Product / Process Change Notification (PCN)

PCN #: PCN_ConCXASY_20200727

Affected Series: 655036032xxx01 / 655035036xxx01
655036032xxx03 / 655035036xxx03
655036032xxx05 / 655035036xxx05
655036032xxx06 / 655035036xxx06
655036032xxx07 / 655035036xxx07
655036032xxx08 / 655035036xxx08
65503N03Nxxx03 / 65503N03Nxxx05
65503NL01xxx03

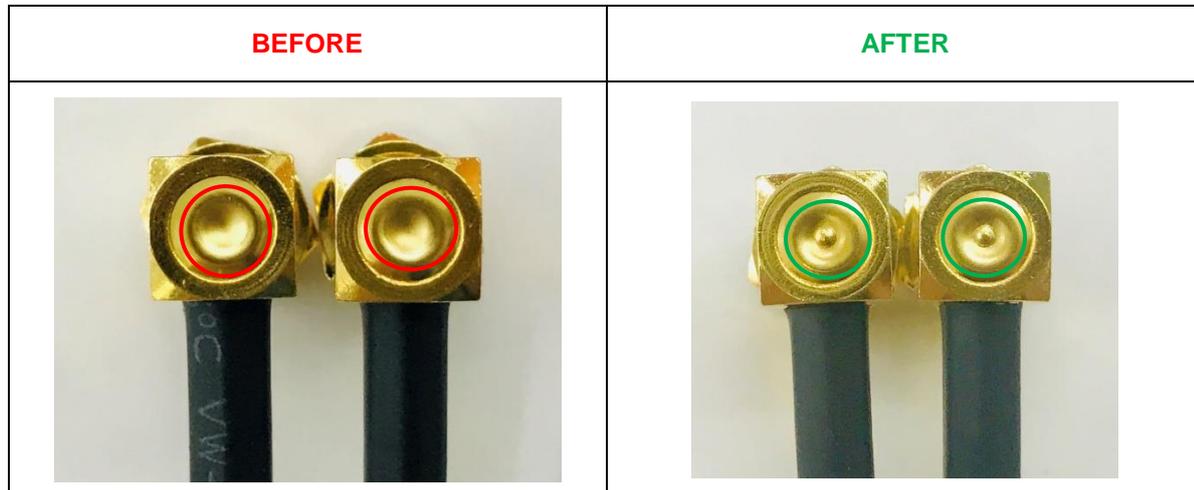
In order to improve plating process quality, Würth Elektronik will change the cover design.
All product date code 2020-04-30 or later, will be affected by this change.
There will be no change in fit, function or reliability of the product.

The design of the cover will change. A dimple will be implemented to improve the plating process quality. This cover is for SMA coaxial connector.
